<b>Project</b>	IEEE 802.16 Broadband Wireless Access Working Group < <a href="http://ieee802.org/16">http://ieee802.org/16</a> >	
<b>Title</b>	Action Item from Session #46: Text and Figure fixing comment 544	
<b>Date Submitted</b>	2007-01-09	
<b>Source(s)</b>	<p>Liwen Chu STMicroelectronics 1060 East Brokaw Road San Jose, CA, USA</p> <p>Kyeongsoo Kim STMicroelectronics 1060 East Brokaw Road San Jose, CA, USA</p>	<p>Voice: 1-408-467-8436 Fax: 1-408-452-0278 <a href="mailto:liwen.chu@st.com">liwen.chu@st.com</a></p> <p>Voice: 1-408-621-4913 Fax: 1-408-452-0278 <a href="mailto:kyeongsoo.kim@st.com">kyeongsoo.kim@st.com</a></p>
<b>Re:</b>	IEEE 802.16 Working Group Letter Ballot #24, on P802.16h/D1	
<b>Abstract</b>	This contribution proposes to enhance adaptive channel selection using 2-hop BS working channel ID to increase spacial efficiency.	
<b>Purpose</b>	To consolidate the working document	
<b>Notice</b>	This document has been prepared to assist IEEE 802.16. It is offered as a basis for discussion and is not binding on the contributing individual(s) or organization(s). The material in this document is subject to change in form and content after further study. The contributor(s) res

*Change Figure h38 as follows:*

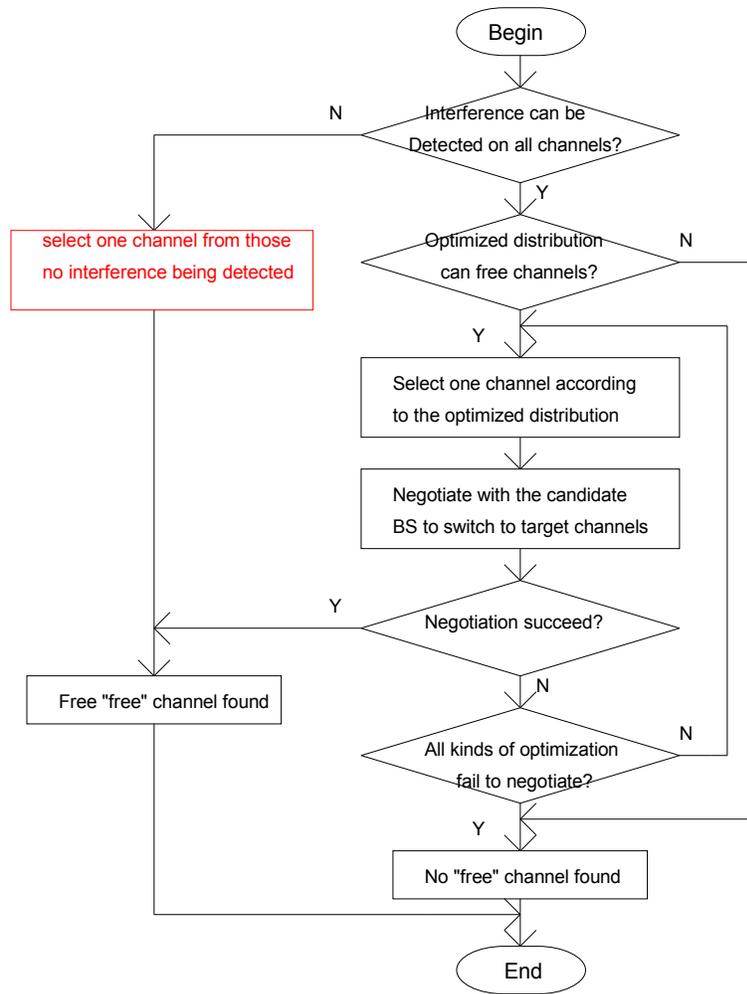
In November meeting, the part 1 of contribution S80216h-06\_101 (slide2 to slide 8) was accepted by the 16h task group. But the editorial change indication is not provided in S80216h-06\_101. Here we provide editorial change indication for the part 1 of the idea proposed in S80216h-06\_101.

The following is the summary of the part 1 of contribution S80216h-06\_101. One of the basic coexistence mechanism of 802.16h is the adaptive channel selection. The IBS (initializing BS) finds a less interfered or less used frequency to work on. The algorithm in the current draft [1] randomly selects a non-interfered channel as IBS's working channel if there is at least one non-interfered channel. This may decrease frequency efficiency, as described in S80216h-06\_101 ([2]). We provides an enhancement to the algorithm in draft [1] to increase the frequency efficiency. The key idea is that an IBS selects one of its 2-hop OBS's (operating BS) working channels which are the IBS's non-interference channels as its working channel. If an IBS can not find such kind of non-interfered channels, it randomly selects one of its non-interfered channels as the working channel.
